RE: **AMENDMENT - Aquatic and Riparian Habitat, Blue Heron Nest and Steep Slopes Development Permit (DP 14A 17)**
Baynes Sound – Denman/Hornby Islands (Electoral Area A)
7652 Ships Point Road (Adams)
Lot 14, District Lot 26, Newcastle District, Plan 17305, PID 003-923-011

To provide information about a request for reconsideration of a Comox Valley Regional District (CVRD) officer's decision to refuse an amendment to Aquatic and Riparian Habitat, Steep Slopes and Blue Heron Nest Development Permit (DP) DP 14A 17 to include a beach access staircase.

RE: **AMENDMENT - Aquatic and Riparian Habitat, Blue Heron Nest and Steep Slopes Development Permit (DP 14A 17)**
Baynes Sound – Denman/Hornby Islands (Electoral Area A)
7652 Ships Point Road (Adams)
Lot 14, District Lot 26, Newcastle District, Plan 17305, PID 003-923-011

To consider an amendment to Aquatic and Riparian Habitat, Blue Heron Nest and Steep Slopes Development Permit (DP 14A 17) to include the installation of a beach access staircase within 30 metres of the present natural boundary (PNB) of the Georgia Strait, within 60 metres of a heron colony and within 7.5 metres of a steep slope.

Figure 3: Staircase Design and Approximate Location

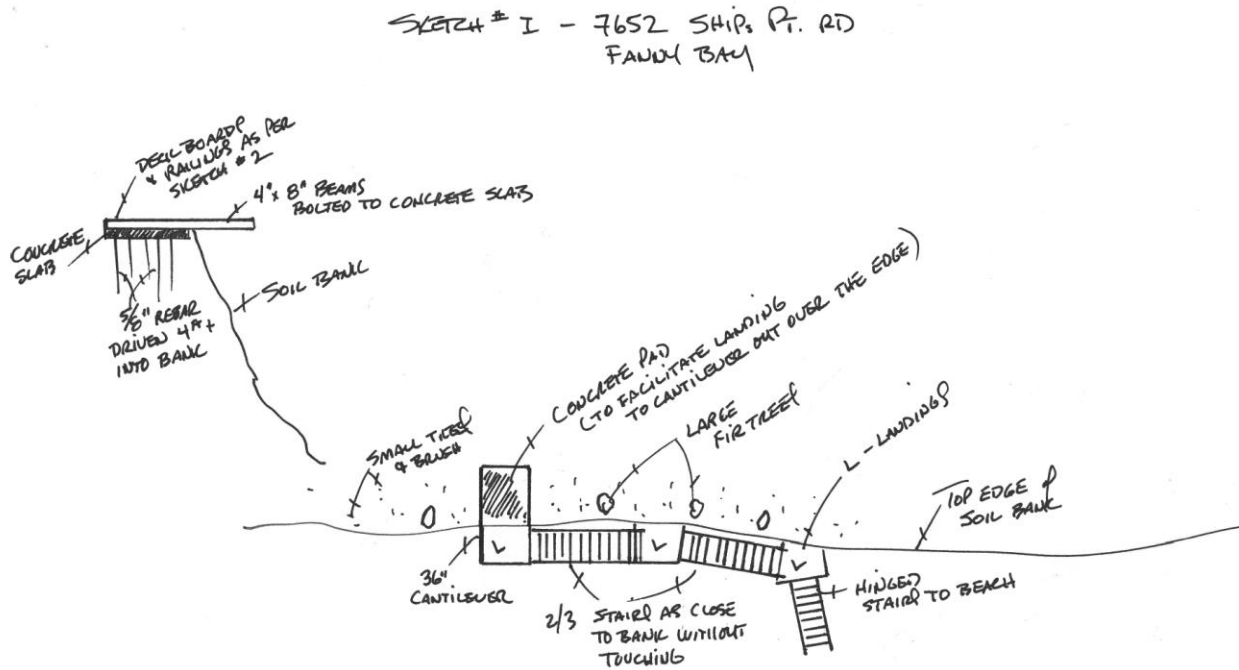
The steep slopes DP requires the submission of a Geotechnical Assessment to assess the proposed activities impacts on the stability of the slope. The applicants submitted an addendum to the Geotechnical Assessment prepared by Johannes Fischer, P.Eng. and Chris Heduc, P.Eng. of Lewkowich Engineering Associates, dated January 16, 2018 (Appendix C). The Geotechnical Assessment reviewed the staircase design drawings prepared by Peter Christenson of Shoreline Designs and had no objections from a geotechnical perspective. A series of recommendations were made in relation to the footings and sediment control during construction. The DP guidelines focus on protecting the stability of the slope and protecting development from hazardous conditions and there is also a DP guideline that states: “*Other than shoreline protection devices, no buildings, structures, driveways, paving, irrigation and water systems, swimming pools, hot tubs, spas and retaining walls shall be permitted within 15 metres of the natural boundary of Georgia Strait*”. The proposal is unable to meet this guideline.

The OCP states: “*Where land is in more than one development permit area, all of the applicable development permit area requirements must be met unless otherwise exempted elsewhere in this bylaw.*” The Steep Slopes DPA and the Heron Nest Tree DPA state that no structures shall be permitted within 15 metres of the Georgia Strait. As such, it is recommended that the application be refused.

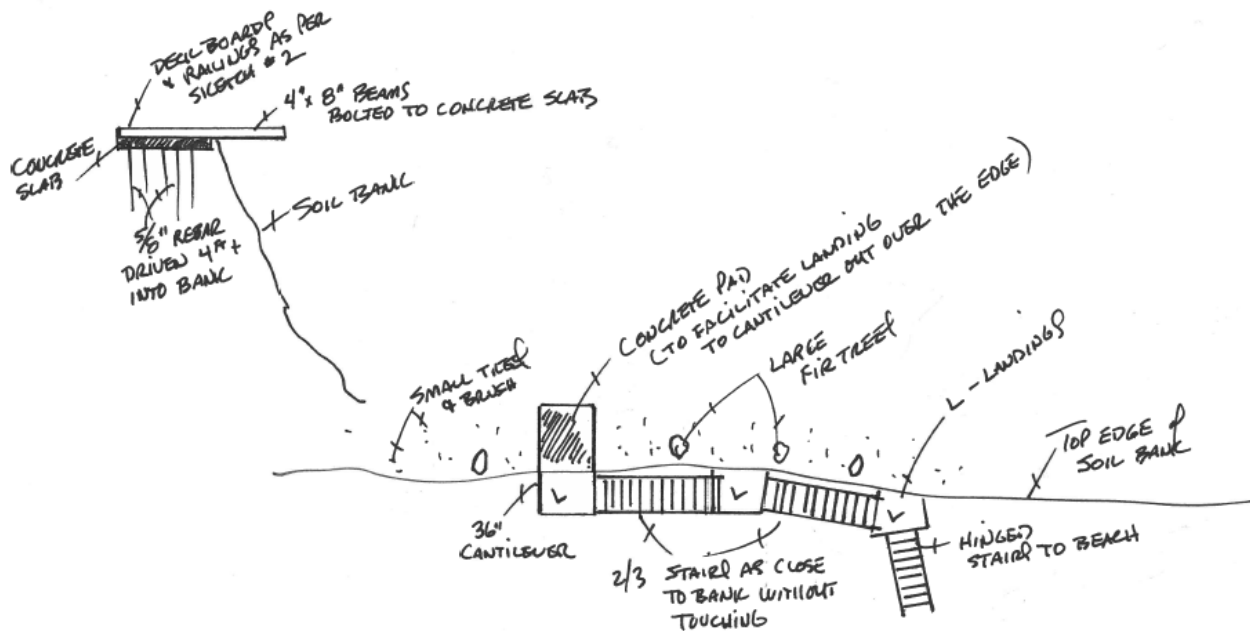
"the biologist's report to provide a more thorough analysis of the impact of the staircase on the shoreline. In particular, the following development permit (DP) guidelines should be addressed in more detail (notes added in blue):

iii. a review of development alternatives that have been considered; [from an environmental perspective why is a staircase preferential to a steep trail](#)

iv. inventories of the existing environmentally sensitive features and natural features including rare and threatened plant communities, endangered species and identified critical habitats; describe the physical shoreline characteristics/backshore habitat. The geotechnical report notes that this area is part of an eel grass and fish spawning habitat

v. assessments of the environmental impact of the proposed development; [what will be the impact of the staircase on natural coastal processes](#)

vi. all proposed protective measures; [how will the least impact be achieved? Eg. no tree removal, small footings, etc](#)

To answer this question I will compare the ground impact of the proposed staircase with that of a trail.

With the **area of the proposed staircase**, the drop from the level surface at the top of the bank to the shore is approximately 13 feet (4m) at a 45° slope. The proposed staircase as shown in the sketch design (shown below) includes eight concrete posts in the ground (supporting two landings) and a concrete pad at the upper start of the staircase. My calculation for the surface area of what touches the ground for these features, once installed, is 22 sq. feet (2m²) [based on 2 sq. feet for the combined eight posts + 20 sq. feet for the upper approach]. It is recognised that there would be additional disruption of the soil when installing the posts for the two landings, but once in place the concrete supports would be considered as environmentally inert (like rocks).

To calculate the **area of trail to the beach** I have used the BC Ministry of Forests manual for recreational trail management (BCMF 2018). The manual discusses various slopes and suggests that safe walking trails at less than 10% (6°) should not encourage erosion. The bank at this site is approximately 13 feet high at a 45° slope. An ideal trail would need to be approximately 130 feet (40m) in length. Given that the width of the property is 27.4m wide this would require a switchback. A two foot wide trail (0.6m) at 130 feet plus 5 feet for a switchback would cover an area of at least 270 sq. feet (25m²). This is over 12 times that of the proposed staircase. To excavate the bank to achieve a level trail surface would likely require an additional, but temporary, disruption of the vegetation about four times the foot print of the trail (another 100m² of disturbance). I suggest that when building a beach trail it would be extremely difficult to achieve a satisfactory regeneration of natural vegetation without further erosion.

The physical shoreline characteristics / backshore habitat are shown in Photograph 1. The proposed staircase would not touch the beach surface influenced by the marine tides. The mentioned “eel grass and fish spawning habitat” is well below any point of contact with the staircase. Eel grass is off shore, typically just below the low tide mark, though occasionally exposed at lowest tides. Spawning habitat for some fish species (herring) is within the eel grass. Other species (smelt and several species of “baitfish”) spawn in the beach sands and gravels near the shore and will not be touched by the proposed staircase.

As mentioned in my original report, beach sediments in the area of this property appear to be building and there is no evidence of erosion along the shore at the base of the bank. It is my opinion that the proposed staircase will have no impact on “natural coastal processes.”

The proposed stair construction involves no tree removal. The eight small footings used to support the two landings are the least invasive approach to supporting the staircase. Once the footings are in place natural vegetation will quickly grow back. My recommendation from Section: **a ix** in my original report stands:
